**PLANNED UNIT DEVELOPMENT
STAFF REPORT****Date: April 16, 2015****DEVELOPMENT NAME**

J. Burmeister, LLC

CONTEMPLATED USE

SITE PLAN

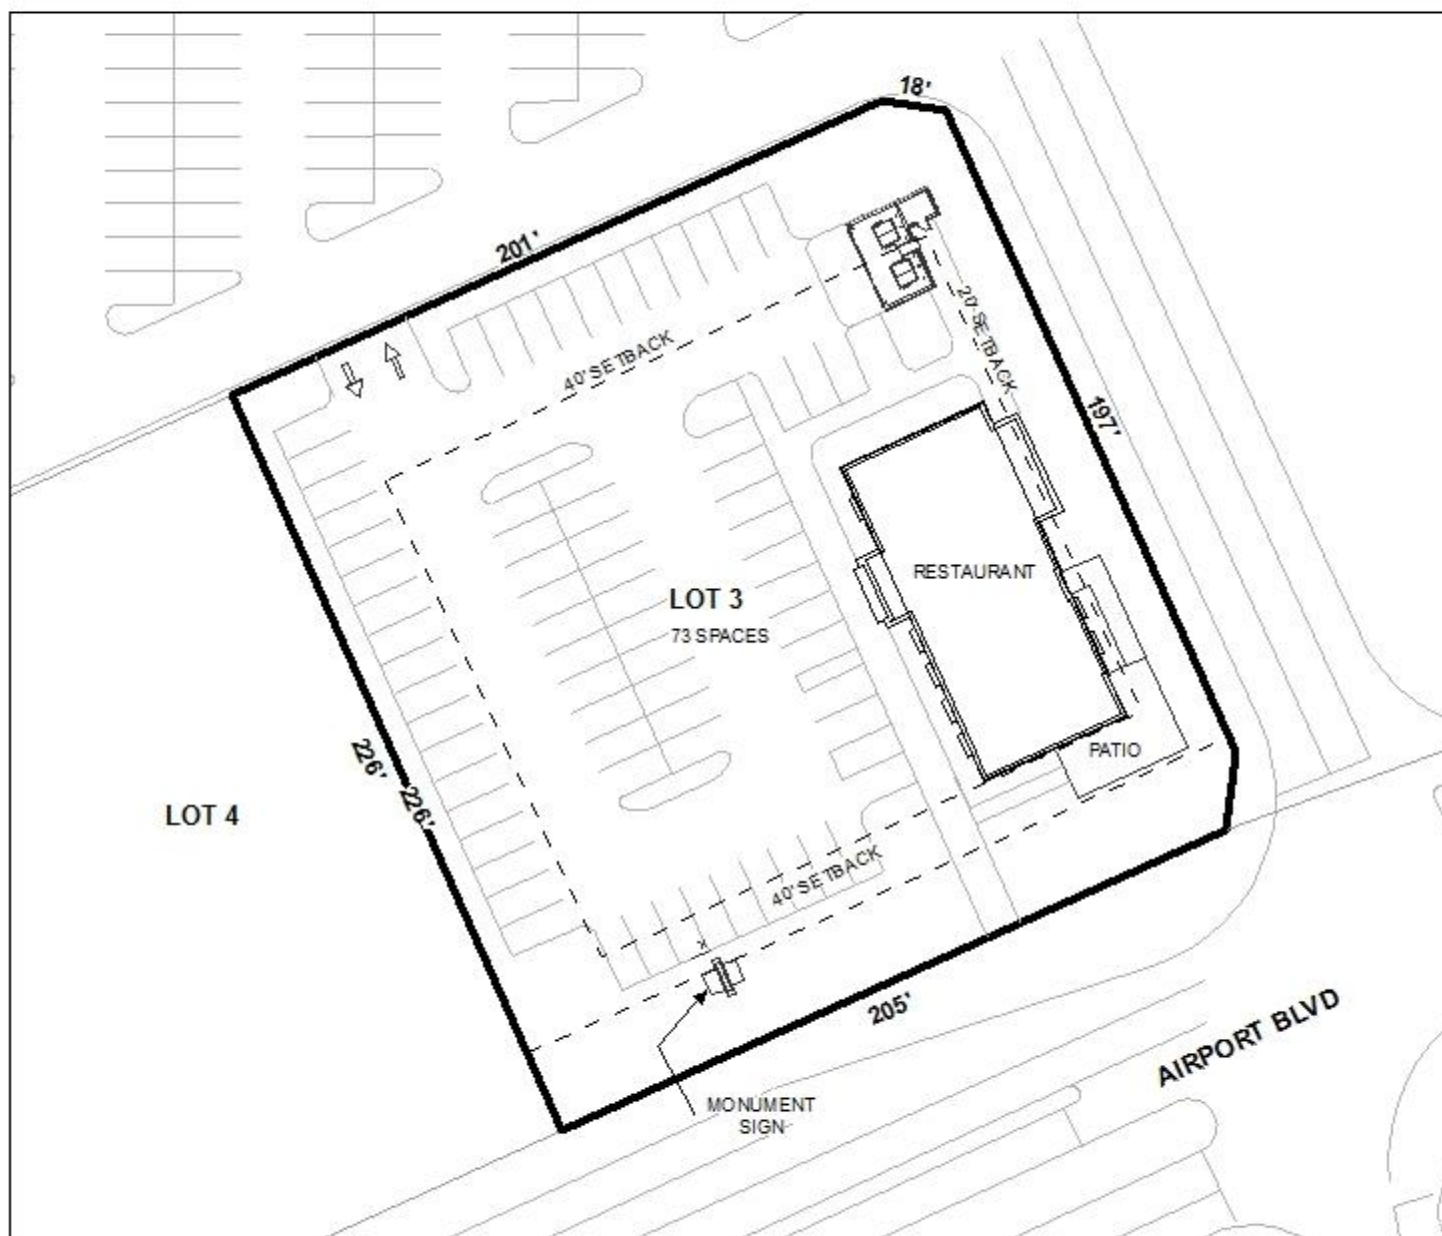
The proposed development of lot 3 will consist of a 4,200 sf restaurant with a 650 sf outdoor patio area. As proposed, there will be 73 new parking spaces, which exceeds the minimum requirements of the Zoning Ordinance for required onsite parking spaces; however, neither bumper stops nor curbing is illustrated. As such, the revised PUD site plan should illustrate the provision of either curbing or bumper stops for all new parking spaces.

Parking lot lighting will be required as a result of the new parking spaces. Any new lighting on the site must comply with the requirements of Sections 64-4.A.2., 64-6.A.3.c., and 64-6.A.8. of the Zoning Ordinance and a note reflecting this requirement should appear on any revised site plan. Photometric plans will be required at the time of permitting for land disturbance.

In regards to landscaping, neither tree and landscaping data nor frontage tree plantings are illustrated on the site plan. The revised PUD site plan should quantify and illustrate full compliance with the tree and landscaping requirements of the Zoning Ordinance. The provision of frontage trees is required along Airport Boulevard.

Dumpsters are illustrated in the northeast corner of Lot 2. The site plan should be revised to illustrate the proposed dumpsters in compliance with Section 64-4.D.9. of the Zoning Ordinance, to include a connection to sanitary sewer.

It should be pointed out that the site plan illustrates a 40' setback along Airport Boulevard and the northern lot line, a 30' setback along the western lot line, and a 20' setback line along the eastern lot line. These setbacks were depicted, but not labelled on the original PUD site plan, thus only a 25' setback is required along Airport Boulevard based upon the recorded plat. The PUD setbacks depicted on the northern, eastern and western lot lines exceed the underlying zoning district setbacks of a 0' minimum or 5' setback for side and rear yards in a B-3, Community Business District. The proposed dumpsters and enclosure, and what appears to be a fence or wall along the eastern side of the building, intrude within the depicted side and rear yard PUD setbacks. Therefore, the applicant should revise the request to include reduced PUD side and rear yard setbacks sufficient to accommodate all proposed dumpsters, walls and/or fences, or the site plan should be revised to illustrate all proposed structures and equipment in compliance with setbacks.

- 1) Revision of the Planned Unit Development (PUD) application to include reduced side and rear yard setbacks sufficient to accommodate all proposed dumpsters, walls, and/or fences; or
- 2) Revision of the PUD site plan to illustrate all proposed dumpsters, walls, and/or fences in compliance with the depicted PUD setbacks.
